ATV
SERVICE
Bulletin

Subject: **RH Mirror Adaptor (Renegade
CE Only)**

No. **2008-6**

YEAR	MODEL	MODEL NUMBER	SERIAL NUMBER
2008	Renegade™ CE	All	All

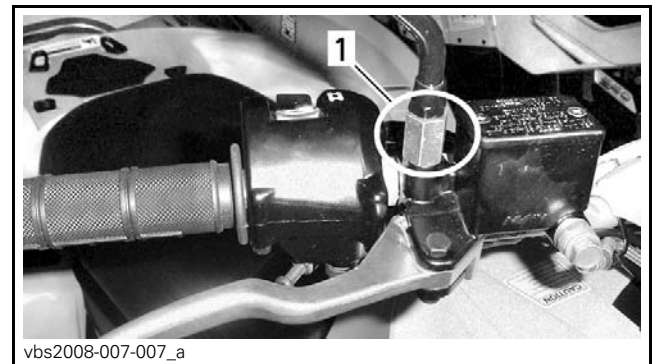
BRP has been informed that certain Renegade CE models left the factory with the RH mirror that would not fit properly in its handlebar support. Threads would not be compatible.

This situation can easily be solved by using mirror adaptor.

Install mirror adaptor [1] between handlebar support and RH mirror.
